TECH BULLETIN 124

Plunger Rod Assembly Change for 2SF/2SFQ Stainless Steel Plunger Pumps

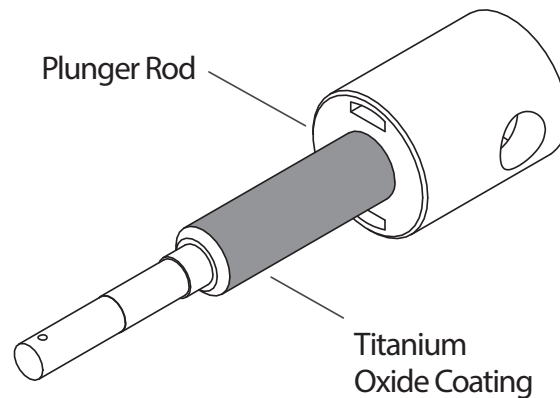
Cat Pumps is implementing a running-change to the plunger rods used in the 2SF series stainless steel plunger pumps: a titanium oxide (TiO₂) coating will be applied to the low-pressure sealing area of the plunger rod. After extensive testing, the titanium oxide coating has proven to significantly reduce wear associated with scoring on the plunger rod surface, resulting in improved service life. See the diagram below for a depiction of the affected area.

The individual plunger rod part number 544695 will be exhausted from stock and change to the new individual plunger rod part number 834203.
